1991 Corvette: Service Bulletin: Squeak and Rattle Diagnosis Guide

Subject: SQUEAK AND RATTLE DIAG. GUIDE DIAGNOSTIC AID/CORRECTION

Model and Year: 1991 CORVETTE

Bulletin Number: 91-264-10 - (03/25/1991)

FIGURE 1

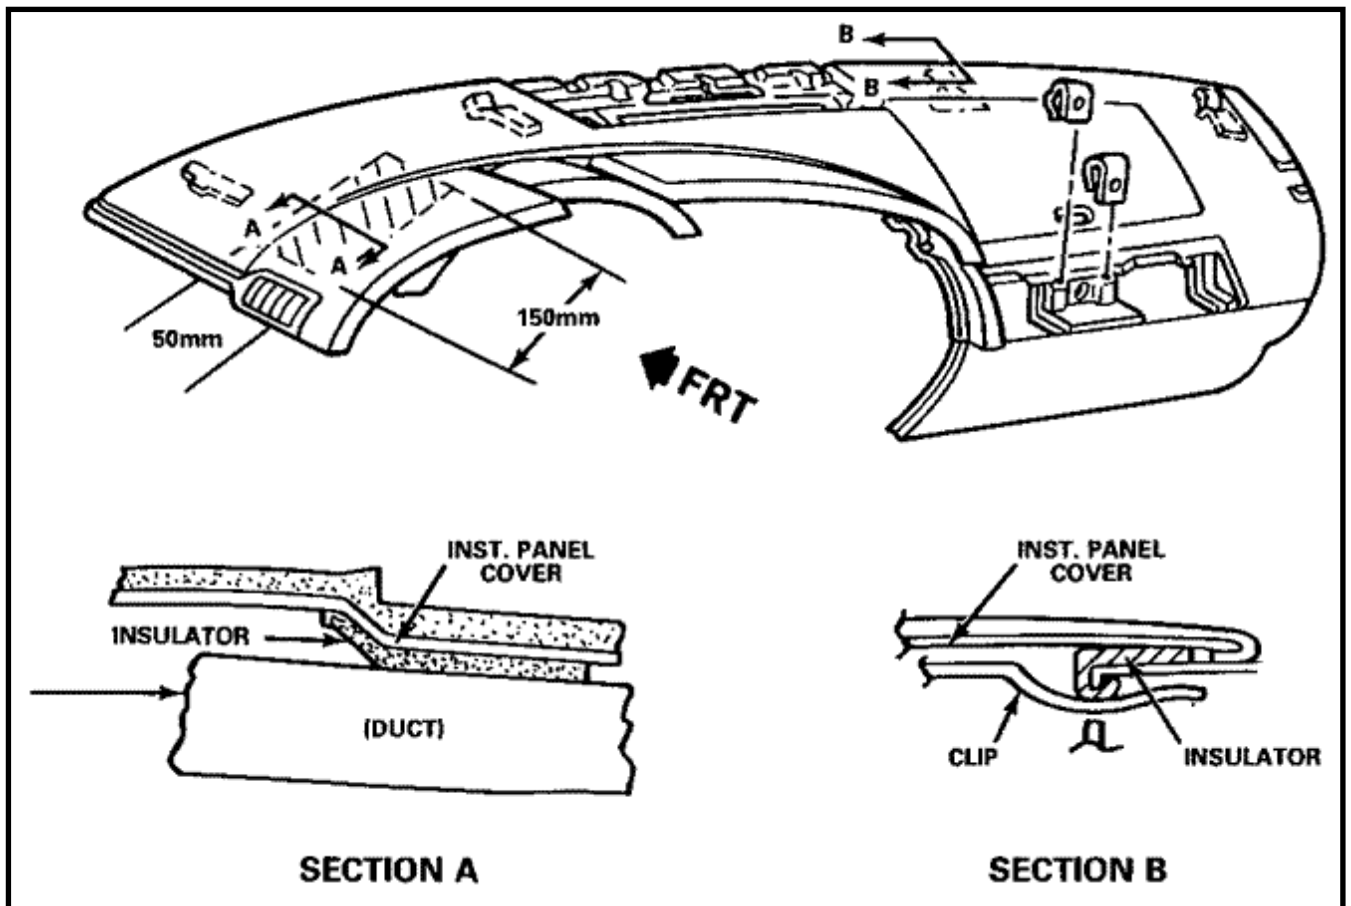
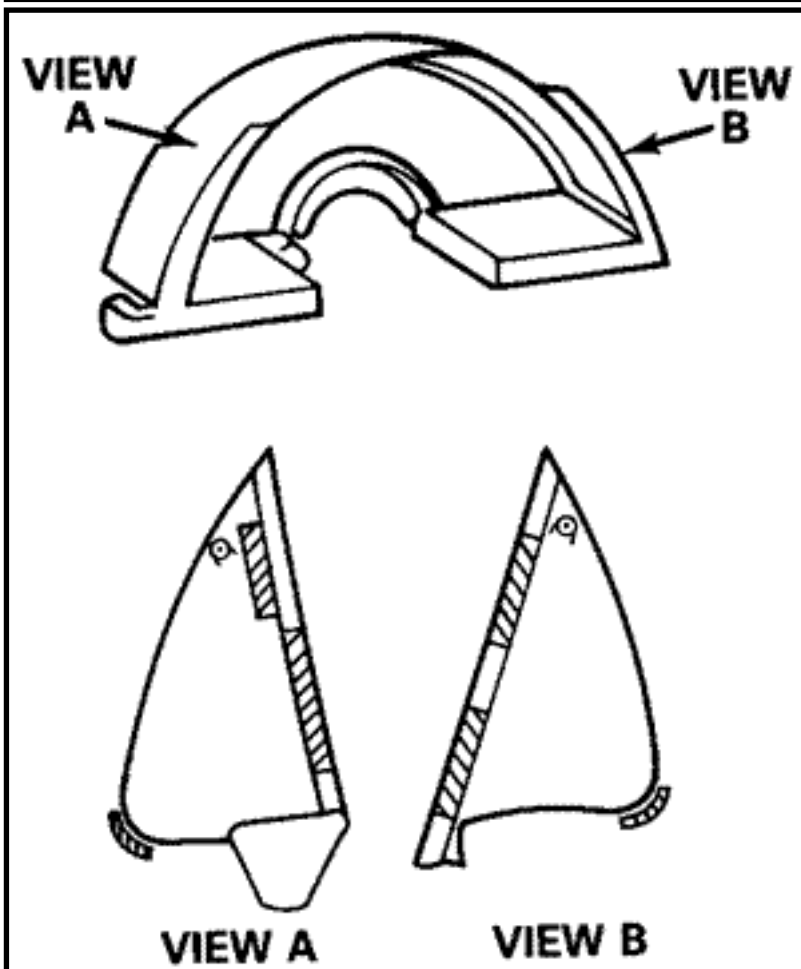
1. Rattle forward of gages cluster 1. Insulate area shown in Figure at A/C cross car duct. 1 and Figure 1, Section A (felt material).

2. Rattle at front edge of cover 2. Reposition existing, or near windshield. install felt insulators on metal opening at all retainers, (see Figure 1, Section B). - Left defogger outlet

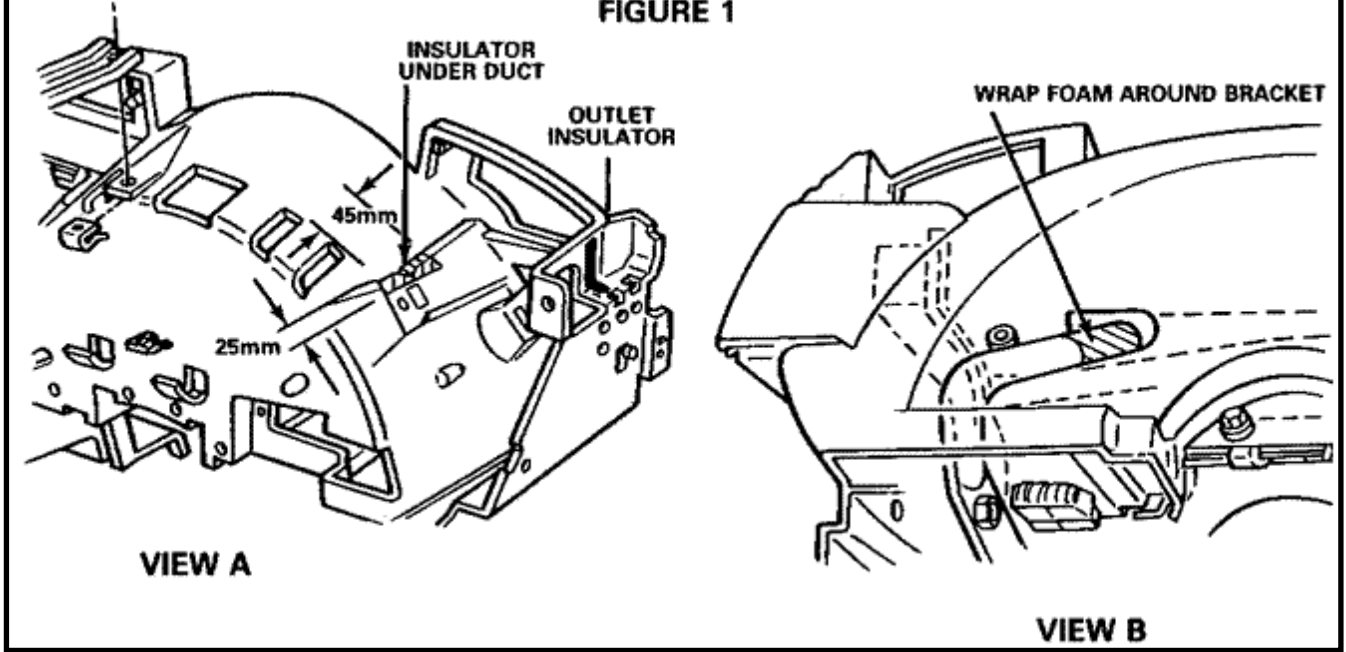
1. Buzzing against instrument 1. Apply felt insulator (1/2" X panel housing. 3"

as shown in Figure 2, view A). - A/C cross car duct

1. Rattle at top of instrument 1. Apply foam insulator (1/8") panel housing. to housing as shown in Figure 2, view A.

2. Rattle at left side SIR 2. Apply foam insulator (1/8") bracket. around bracket as shown in Figure 2 view B. - Instrumentation area

FIGURE 3

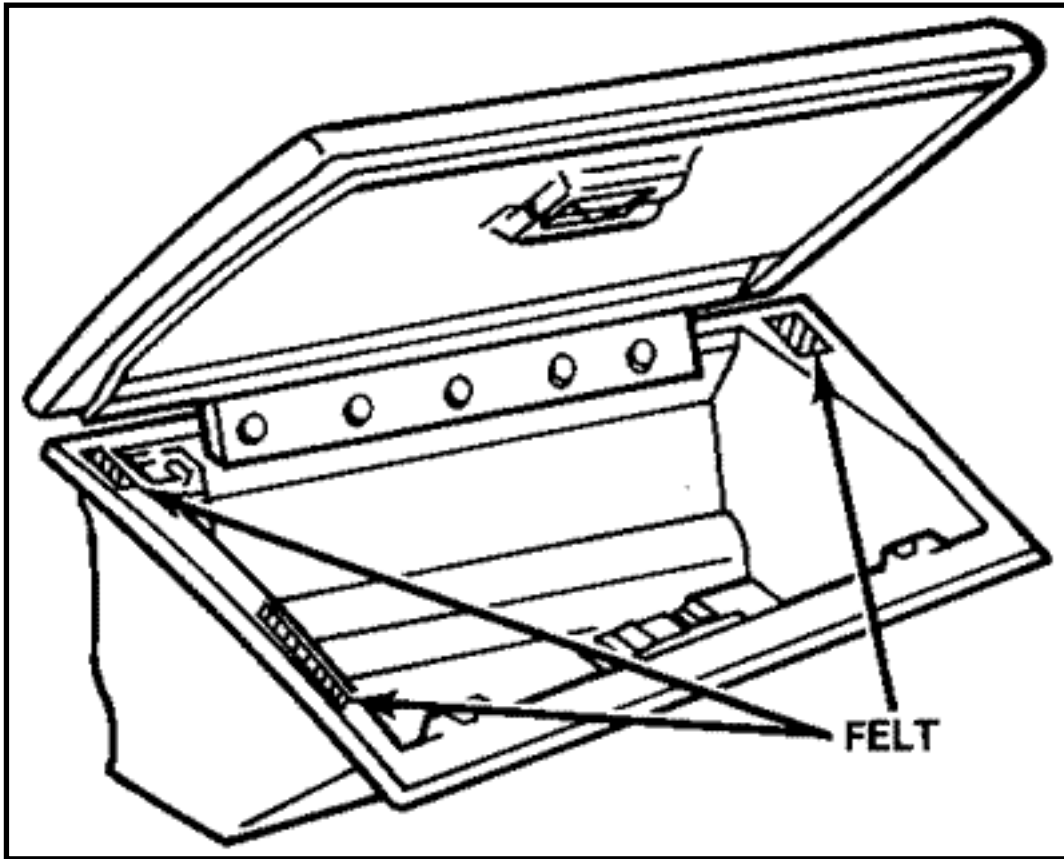
1. Squeak in instrument cluster 1. Apply felt insulators to bezel to cover. bezel edges and surfaces in locations as shown in Figure 3, views A and B.

FIGURE 5

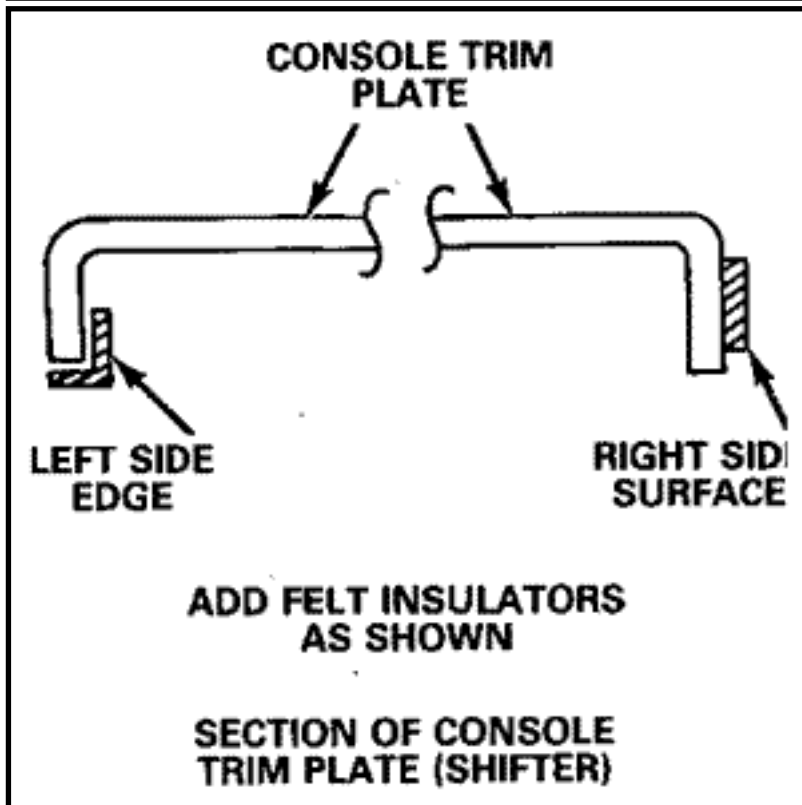
2. Buzzing of fuse box rivet 2. Apply small 1/4" foam heads to instrument panel insulator between rivet head cover. and cover as shown and cover as shown in Figure 5, view A.

3. Buzzing of fuse box door 3. Apply felt insulators (1/4" X in the opening. 1") as shown in Figure 5, view B. Position felt into the radius of the opening.

**REMOVABLE ROOF, FRONT
BOLT AND RETAINER**

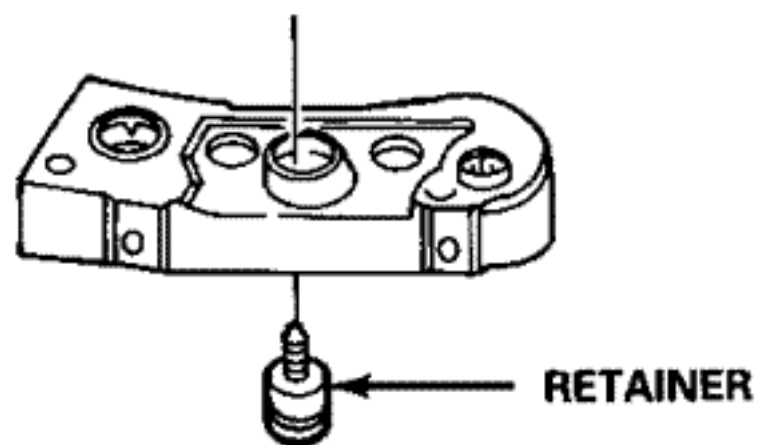
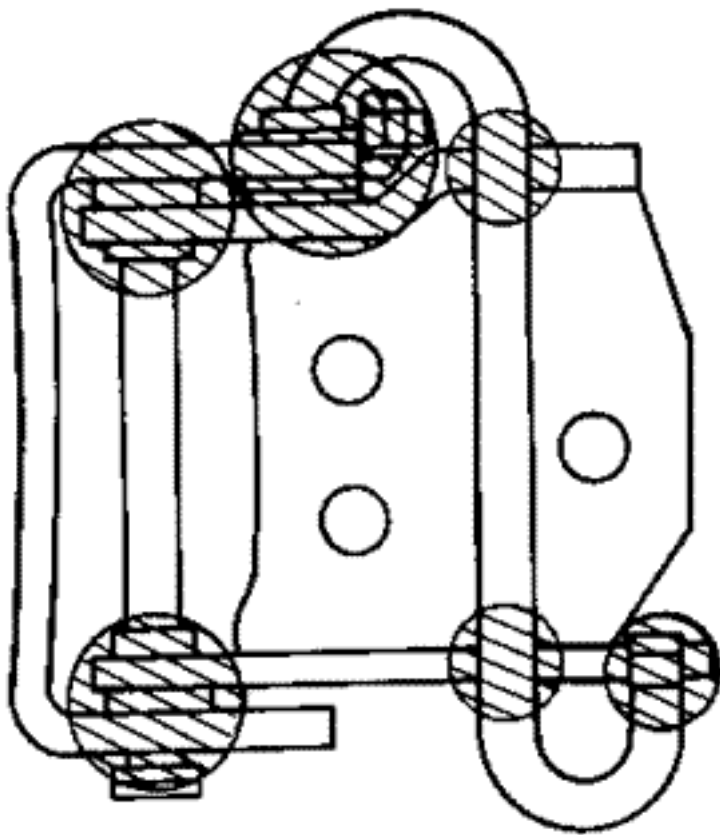
1. Rattle of front attaching bolts 1. Install new bolt retainers, when panel is stowed in rear. P/N 10 1 75804, see Figure 8.

1. Soak new retainers in warm water to aid in installation.
2. Remove roof panel and stow.
3. Remove upper trim covers at right and left latch areas.
4. Remove right and left sun visors, inside mirror and center garnish molding.
5. Carefully pry original retainer and bolt out of housing using a flat blade screwdriver or other suitable tool.
6. Install bolt in new retainer, align locating rib on retainer with notch in housing and press into place with a "C" clamp and socket.
7. Reinstall garnish molding, inside mirror, sun visors and upper trim covers.

**LUBE AT SHADED AREAS
DOOR UPPER HINGE**

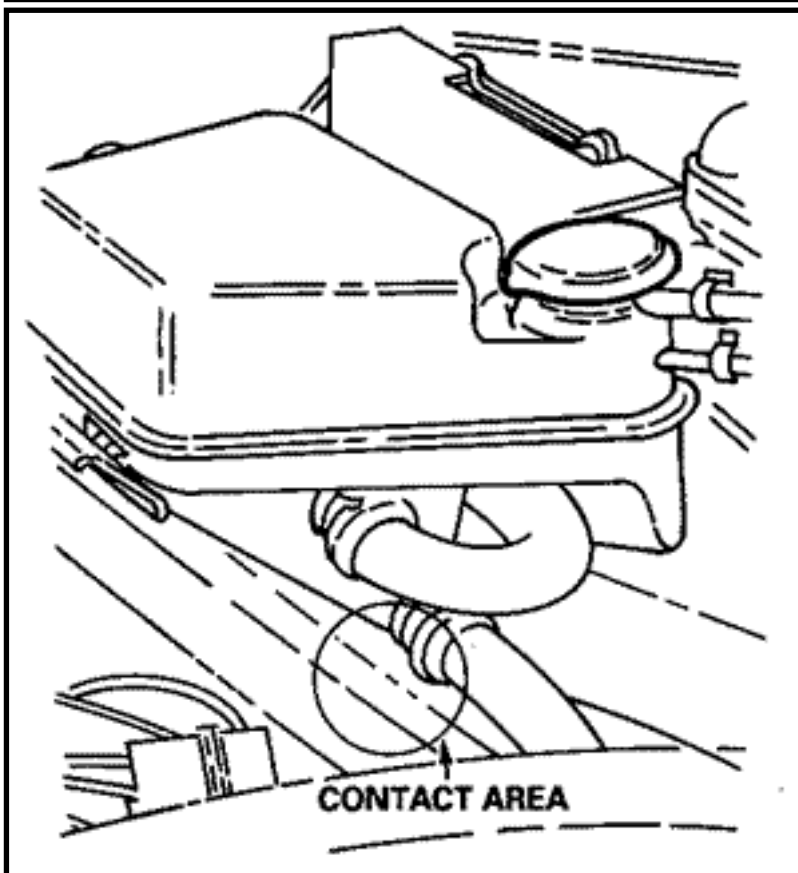
1. Squeaks when opening doors at 1. Lubricate ALL hinge torque hinge torque rod contact areas. rod contact areas with 30 wt. motor oil or grease, see Figure 9. UNDER THE HOOD ----- COMPONENT
